Announcement

Pemko Announces Improved Hardware for Sliding Door Systems

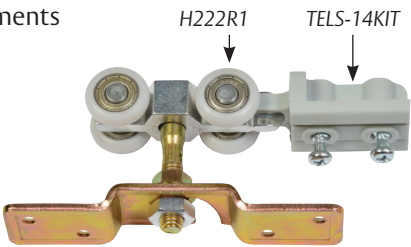
The new **H222R1 hanger**, which replaces the 284 hanger, is constructed with a zinc alloy body and wheels. The wheels are coated in nylon for a smoother, quieter operation and require less than 3lbs of force to move a 200lb door. The 286 clip stop has been replaced by the **TELS-14KIT** which adds an additional screw for better in-use durability.

Hardware kit H100/200PACK has been replaced by the new kit **H200PACK** that contains these updated components.

Because of the changes above, 284, 286 and H100/200PACK are discontinued immediately.

Existing Part Number	New Part Number
284	H222R1
286	TELS-14KIT
H100/200PACK	H200PACK
